August 3, 1984

HOPE CREEK GENERATING STATION  
DOCKET NO. 50-354  
DRAFT SAFETY EVALUATION REPORT  
OPEN ITEM STATUS

In addition, enclosed for your review and approval (see Attachment 4) are the resolutions to the Draft SER open items, FSAR question responses and structural geotechnical audit item responses, listed in Attachment 3.

FIGURE A-16-9

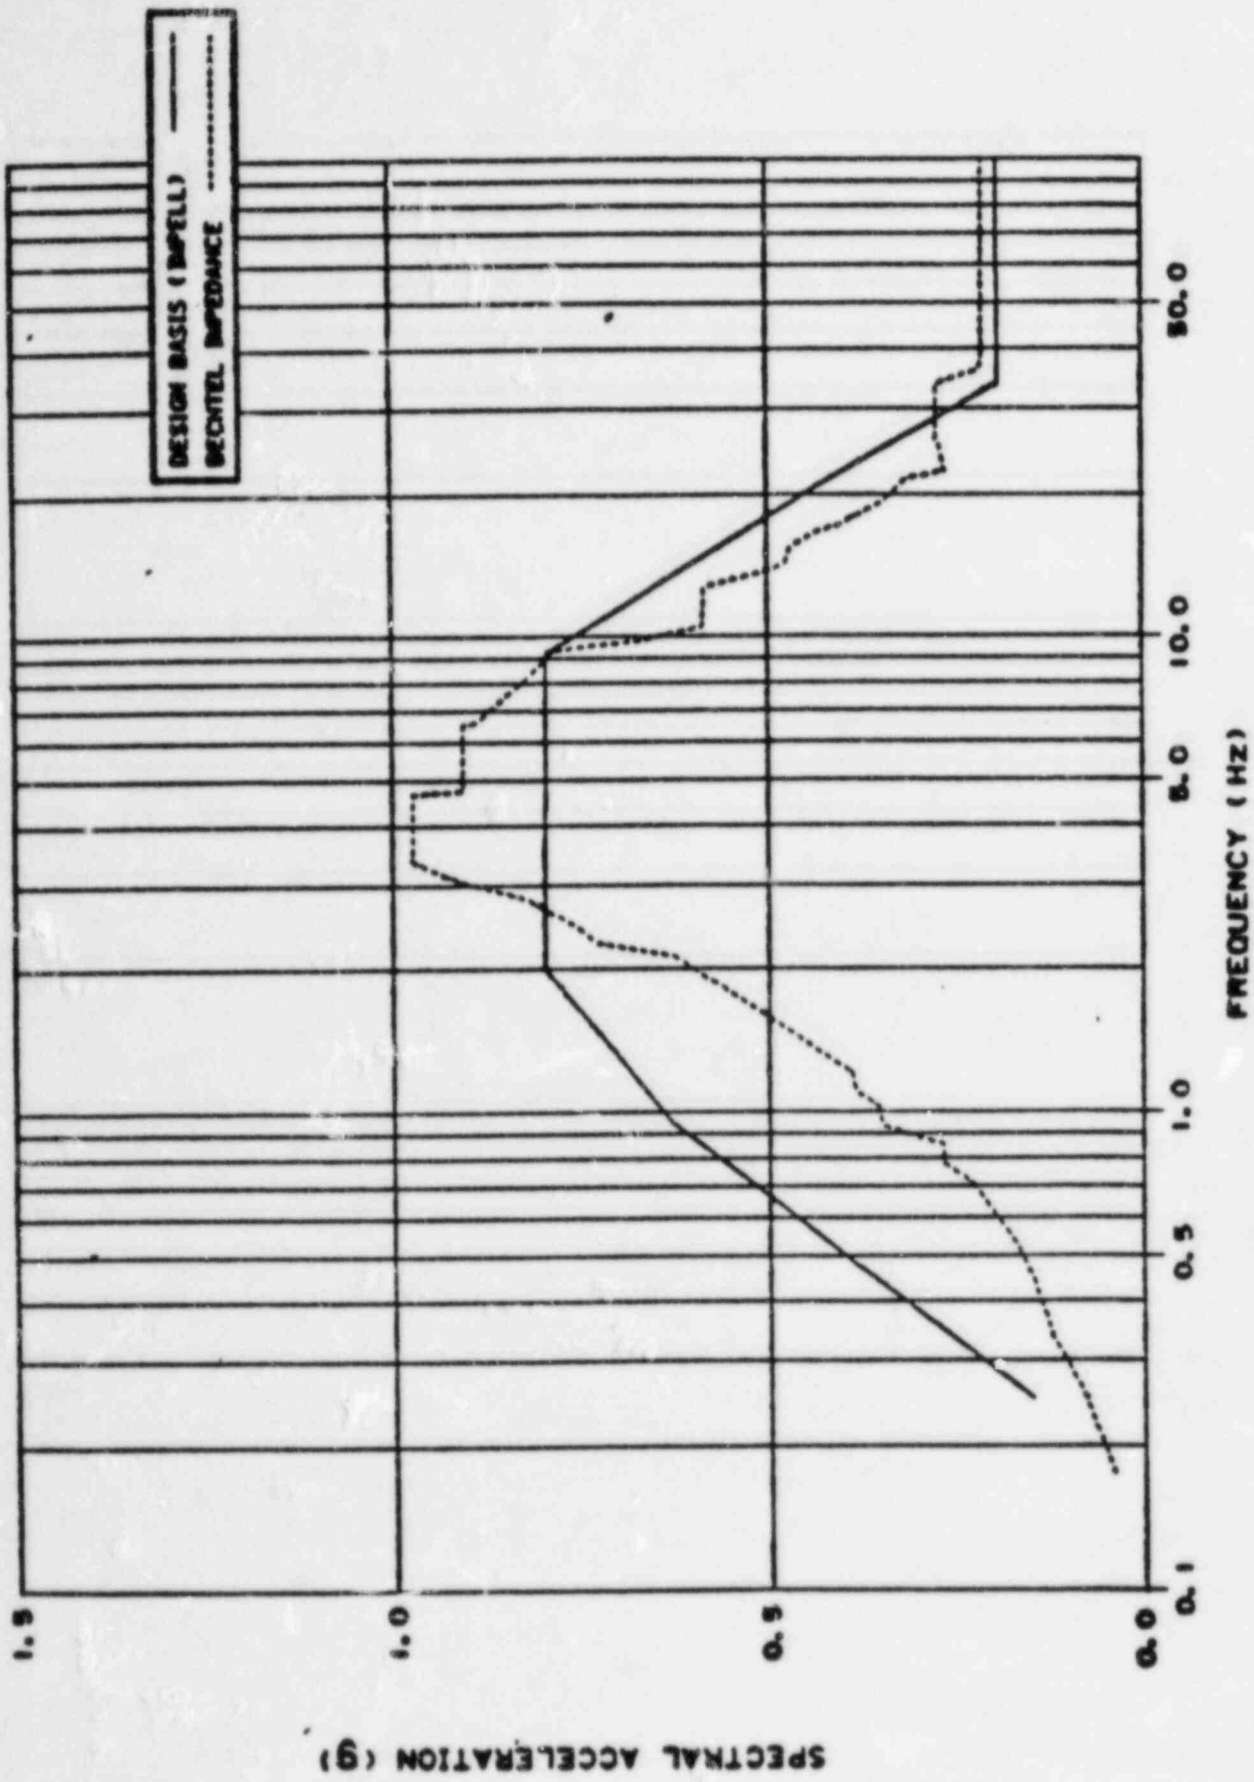
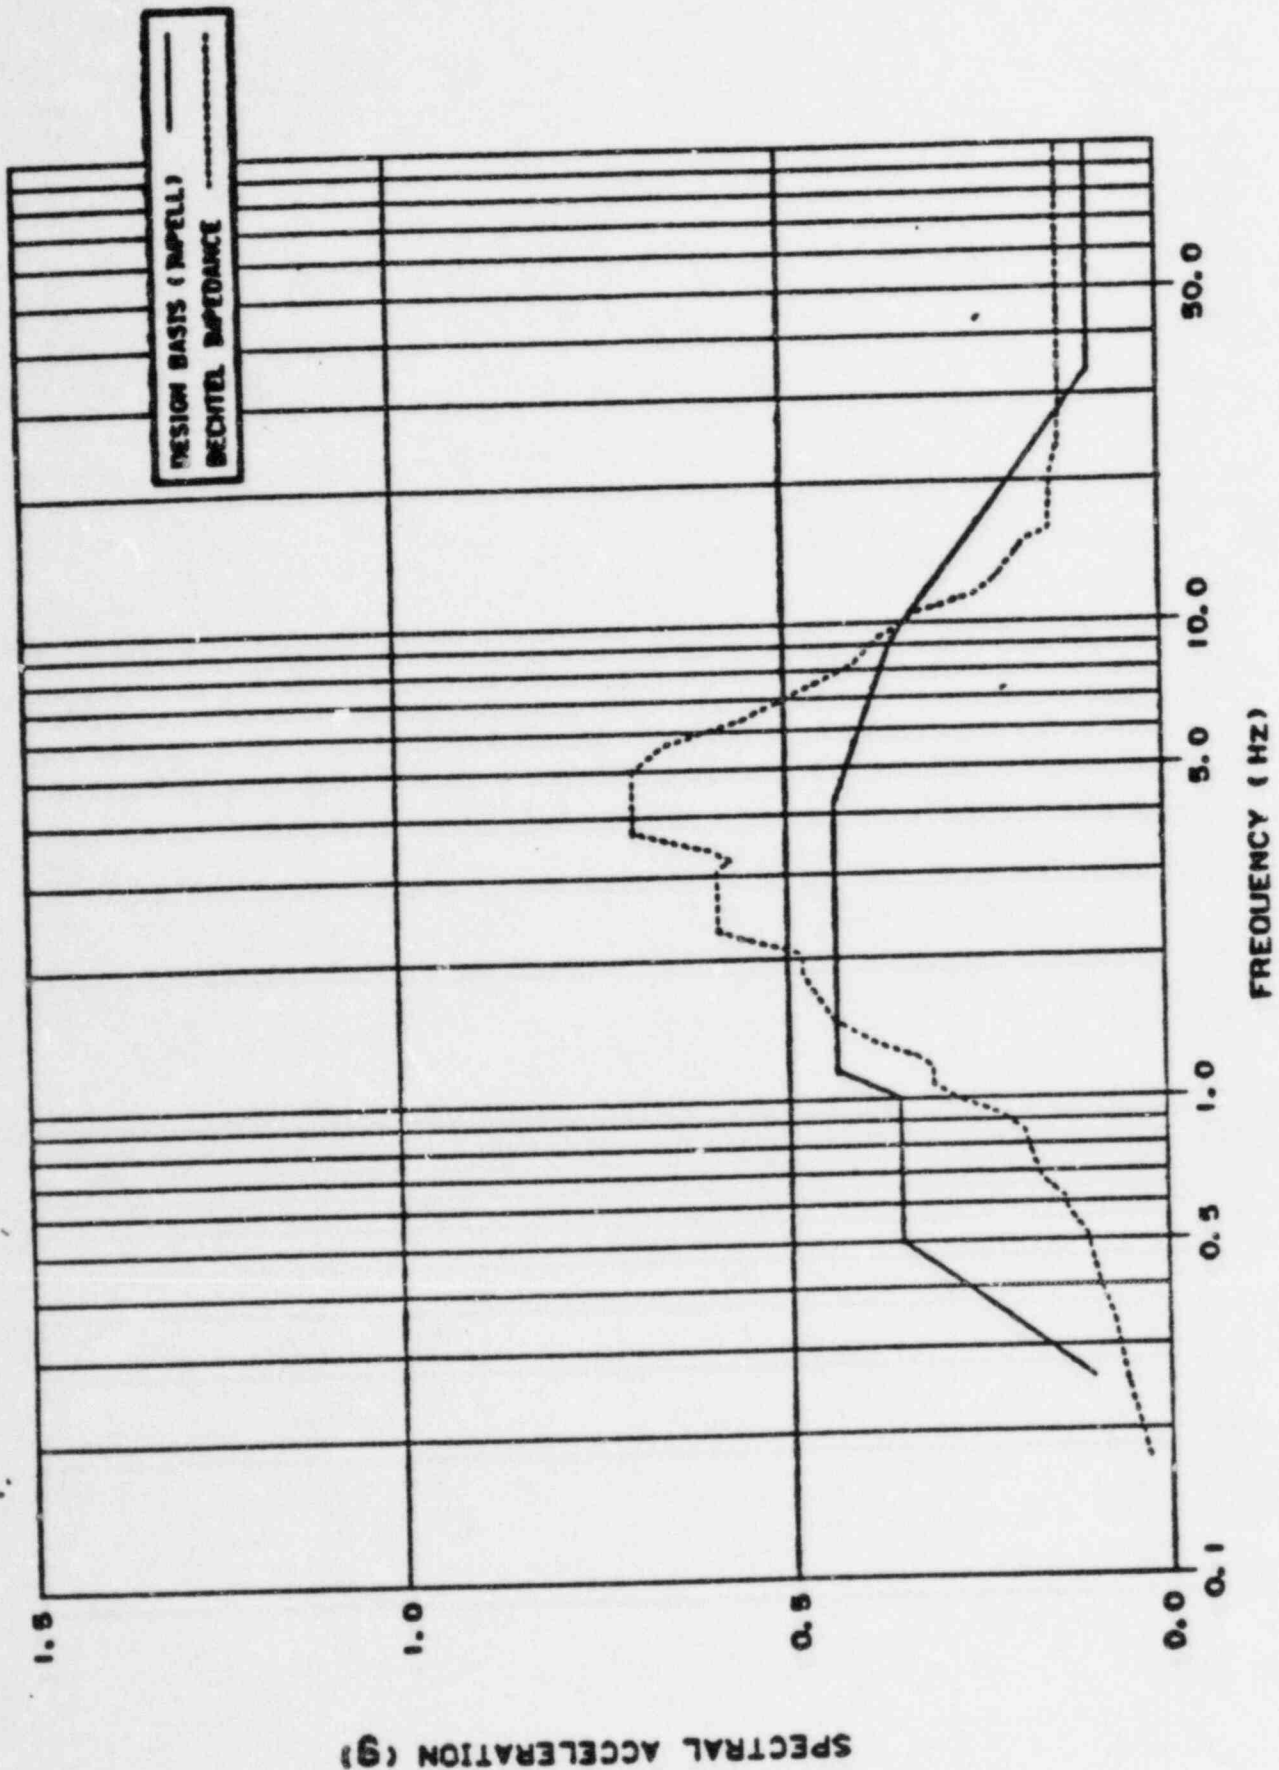
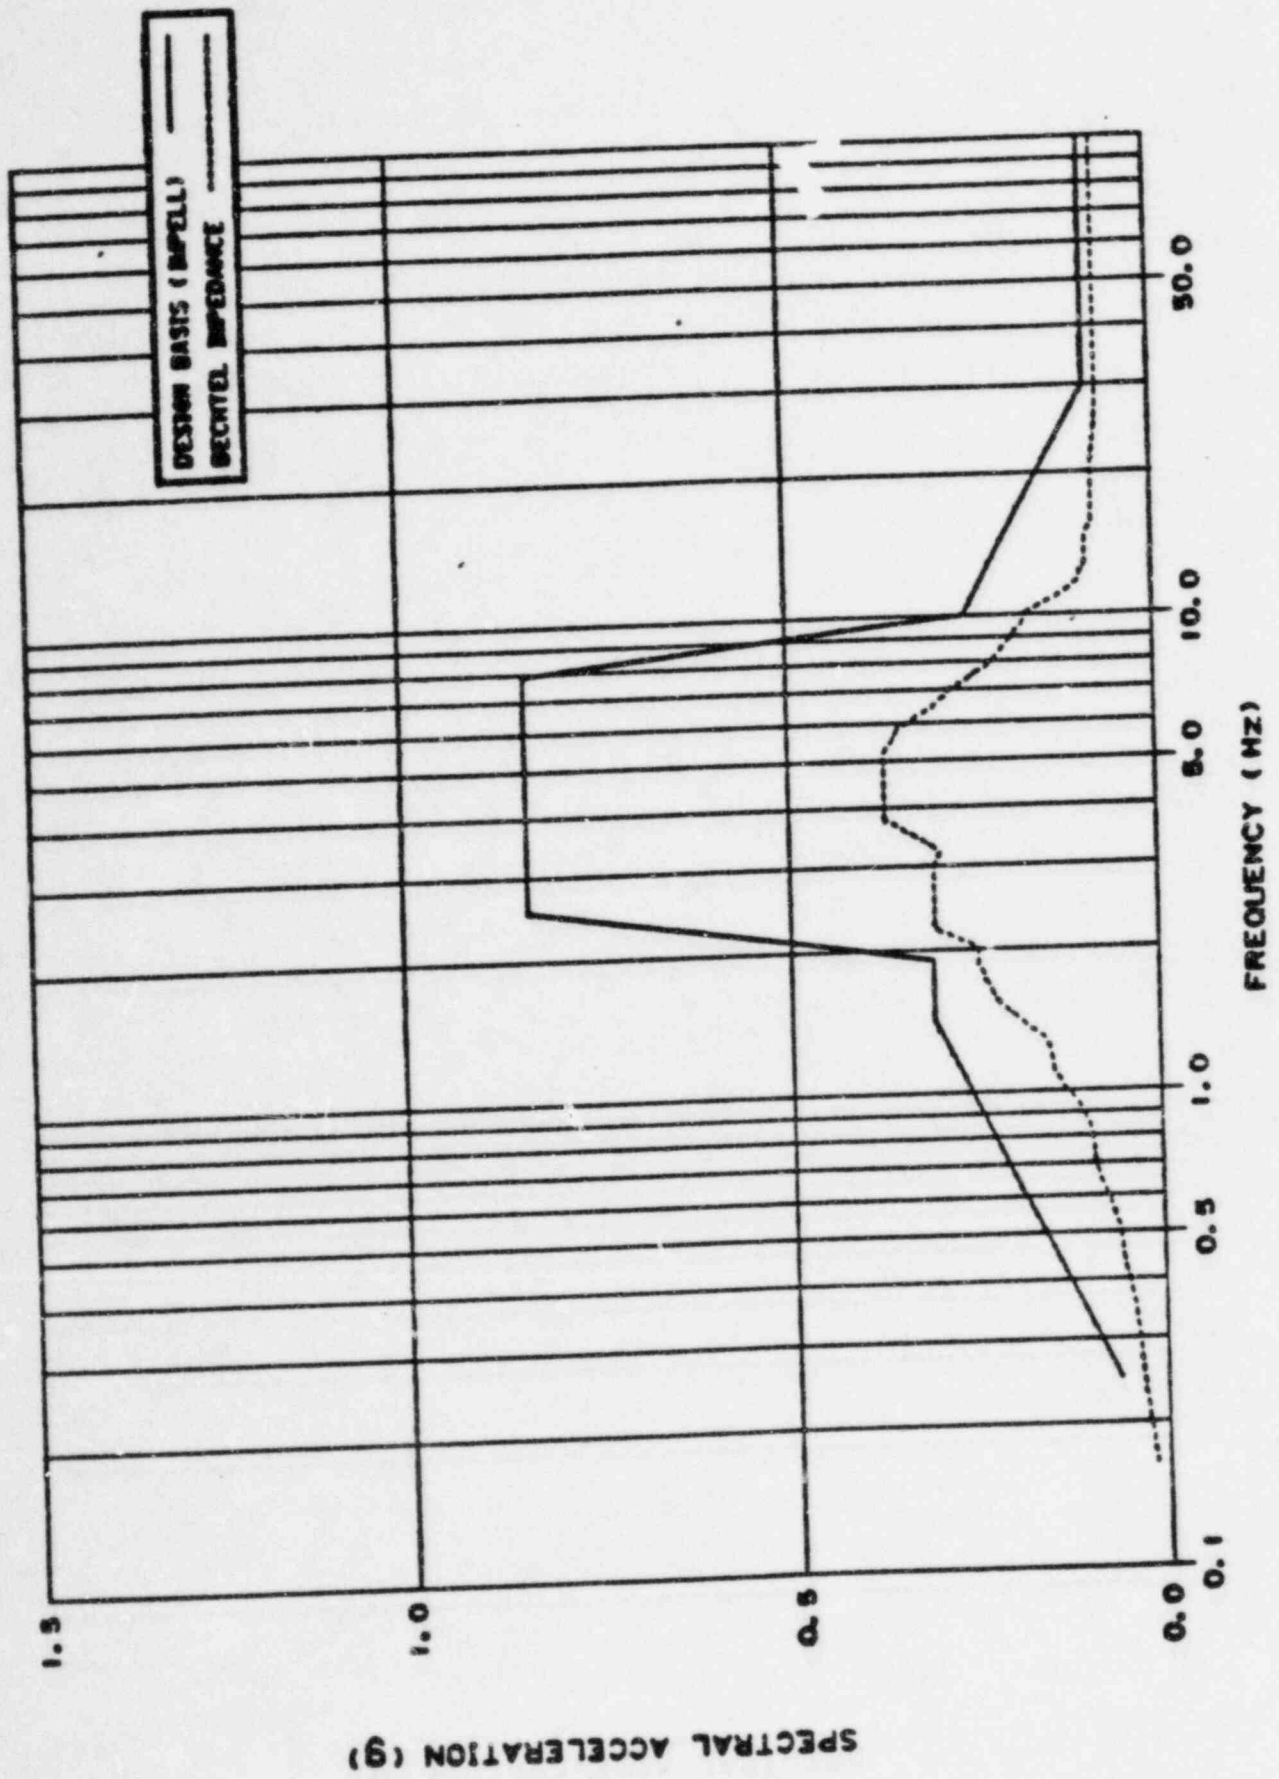
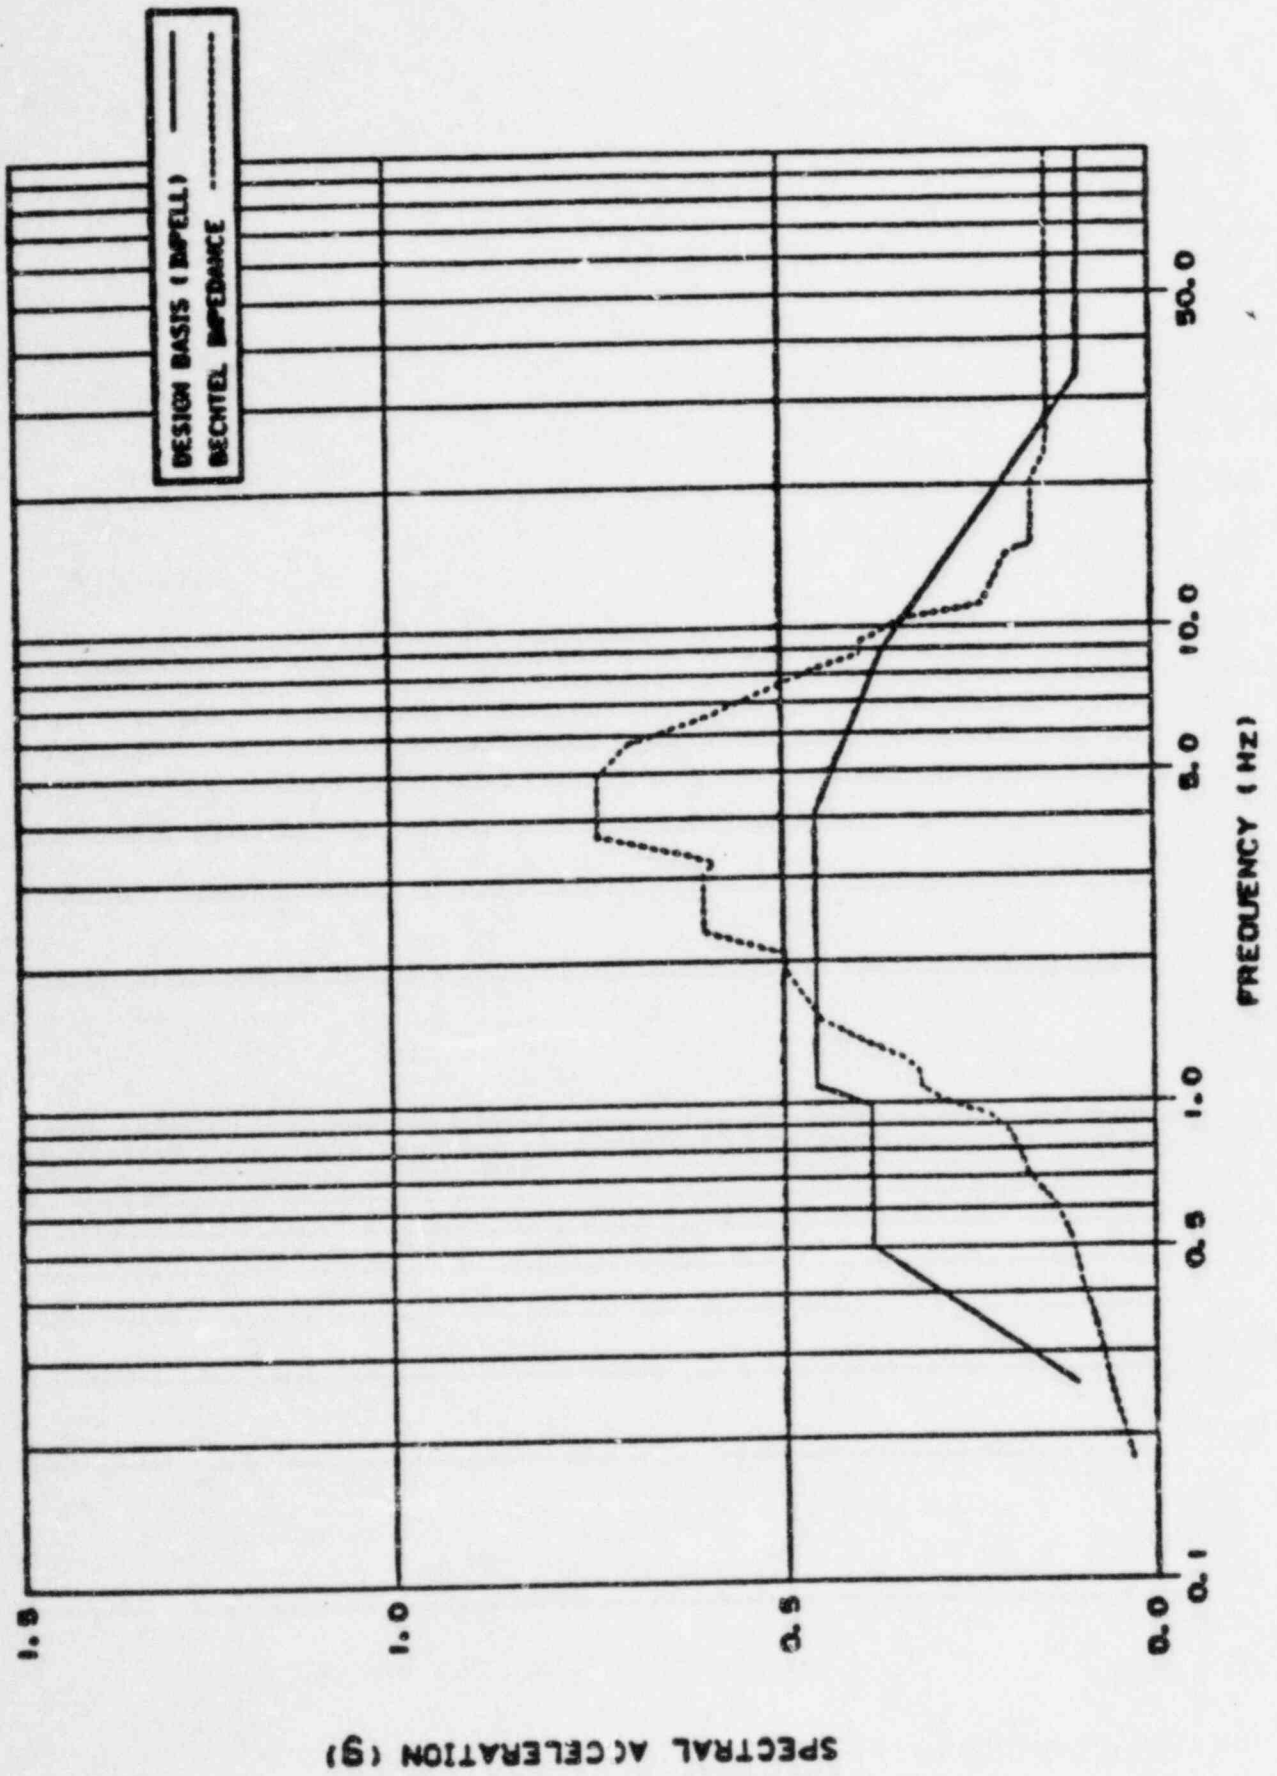
Response

Figures A-16-1 to A-16-18 show the comparison of the 2 percent damping response spectra obtained from the design basis finite element and the impedance approach seismic soil-structure interaction analyses. The impedance approach response spectra generally are enveloped by those obtained from the design basis analyses at elevation 114.0 feet of the SWIS. For other elevations, the impedance approach spectral accelerations exceed the design basis spectral accelerations in some frequency ranges. These ranges vary approximately between 1.5 and 10.0 Hz.
